GUILD LIVING at EPSOM

19/01722/FUL

Design Response to EEBC Planning Comments 17/04/2020
Car Park Facade

24 April 2020

Facade Bay Study - APS Carpark Elevation 3D [4.22 in validated DAS]

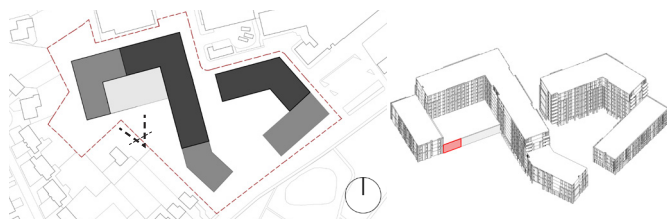
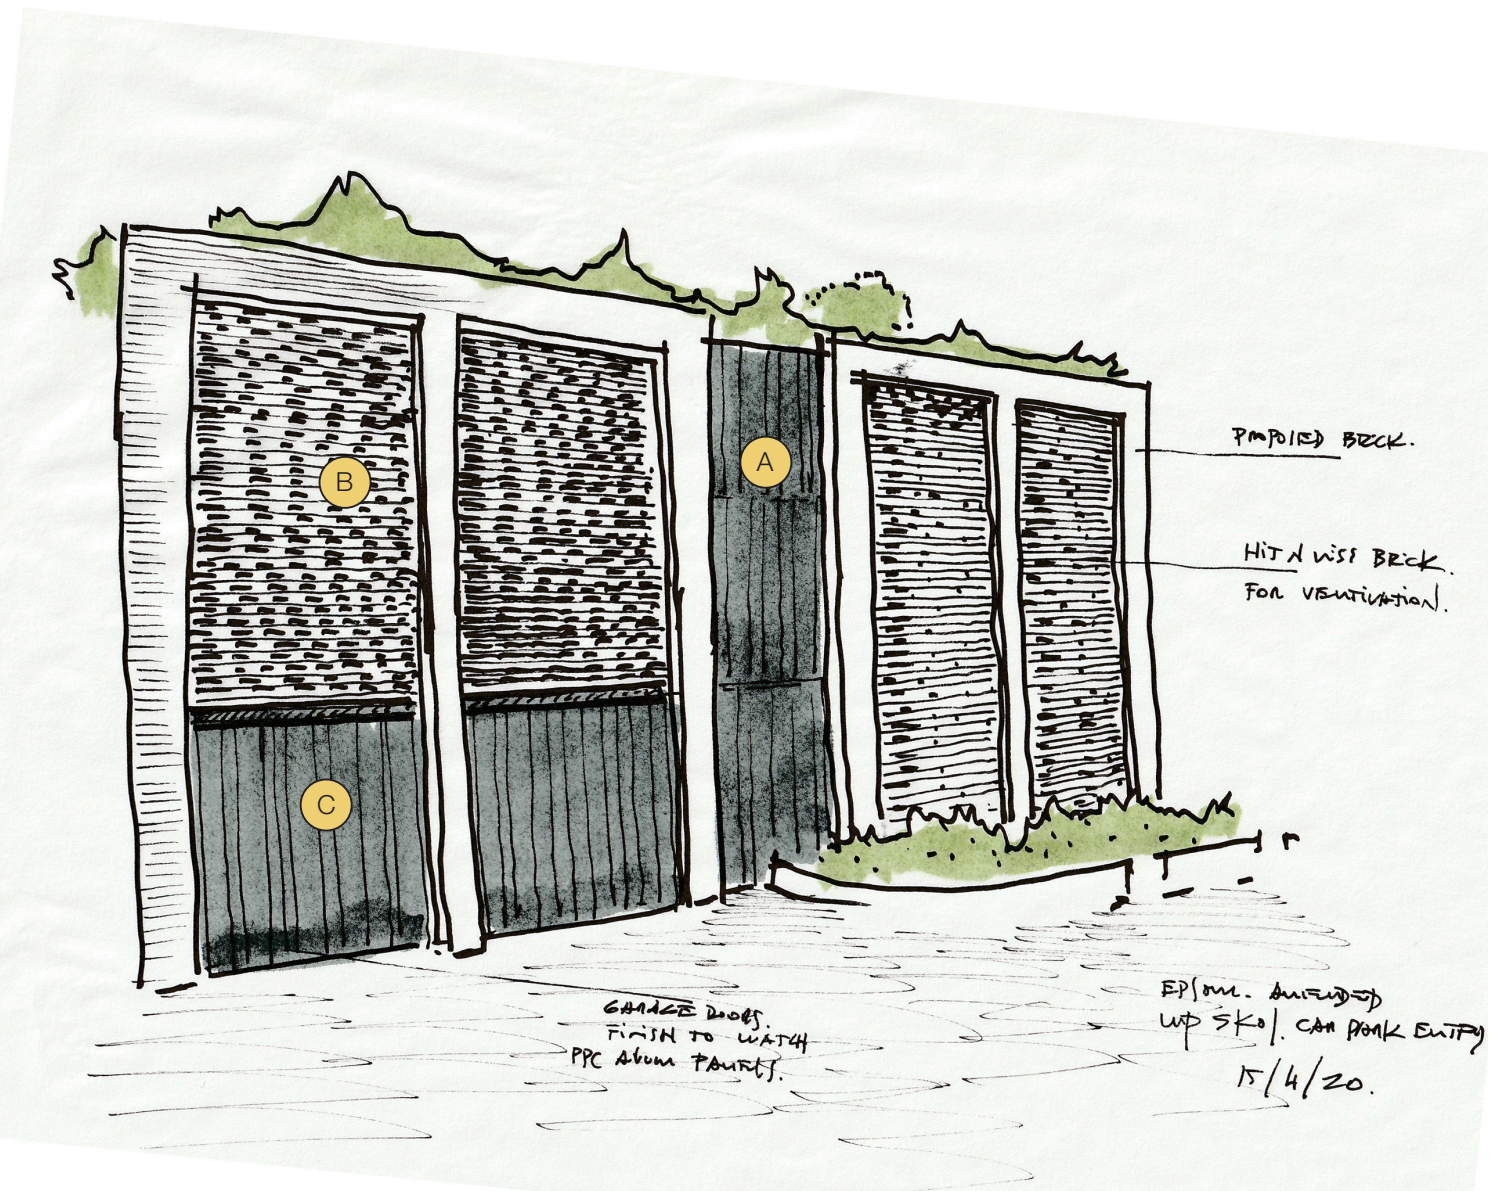
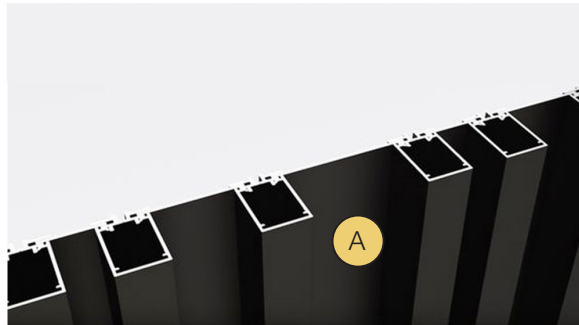
Comments from EEBC design officer Virginia Johnson & Lance Penman
17/04/2020.

...The car park entrance shown on 4.22 is harsh and industrial in appearance and the details of the aluminium surface and the garage doors should be reconsidered.
